Secured by Design

Meeting held with Adam Lindsay at Camden Council on 13.12.16. Comments received by e-mail on 14.12.16 with responses on the following page(s).

Comments & Responses

Ancient Right of Way Elevation & Plan

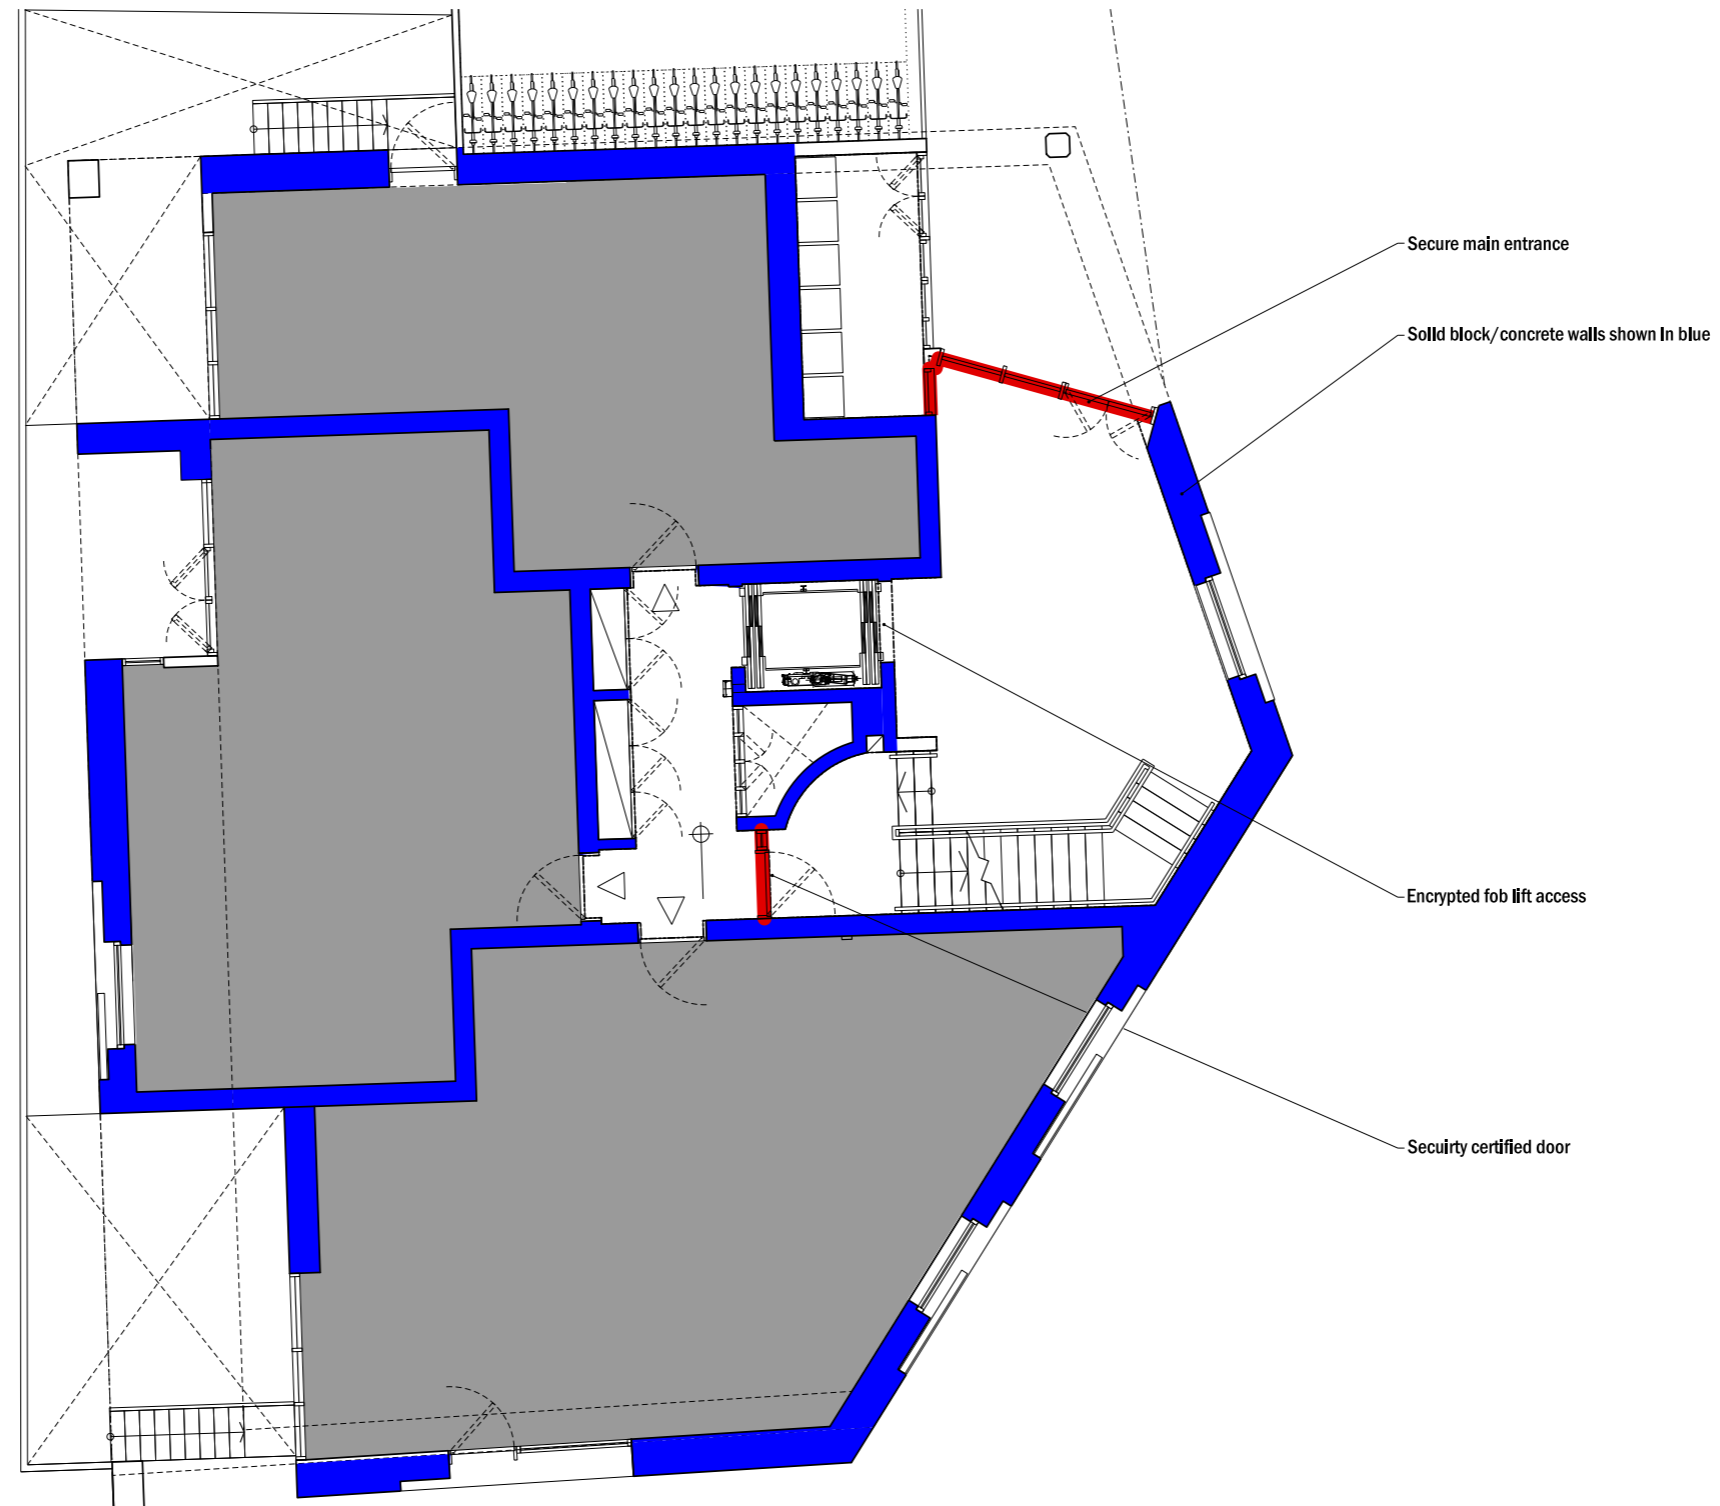
Right Of Way. CCTV will be fitted complying with the information commissioners guidelines, with uniform lighting to BS 5489 with a 40% uniformity. Railings of a design not easy to climb, 2.4m high

Please see attached drawing 1415-PL-SK-104 for plan and elevation of ancient right of way

with proposed heights of railings and relationship of adjacent fence.

CCTV will be incorporated following the commissioners guidelines along the ancient right of way.

Lighting will be designed to comply with public amenity areas in BS 5489.
